## Manual Revisions PJM EMS Upgrade Manual Documentation

Adamy Garcia – EMS Technologies Becky Davis – NERC Compliance Markets & Reliability Committee April 26, 2023

- Most PJM Manuals include EMS references at a high level and do not include vendor specific information and/or displays.
- Three Manuals will be revised to remove specific EMS vendor information:
  - Manual-01 Control Center and Data Exchange Requirements
  - Manual-13 Emergency Operations
  - Manual-36 System Restoration

# Manual 13 revision:Attachment E: Manual Load Dump Allocation Tables

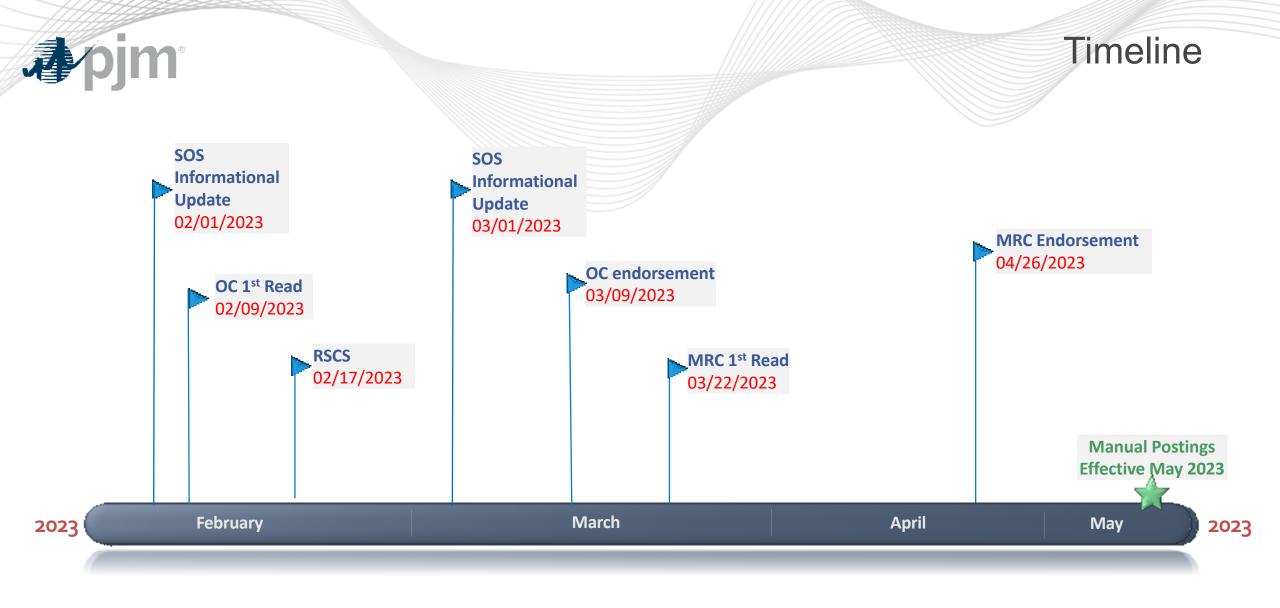
#### **Current Display Revision 86**

New Display Revision 87
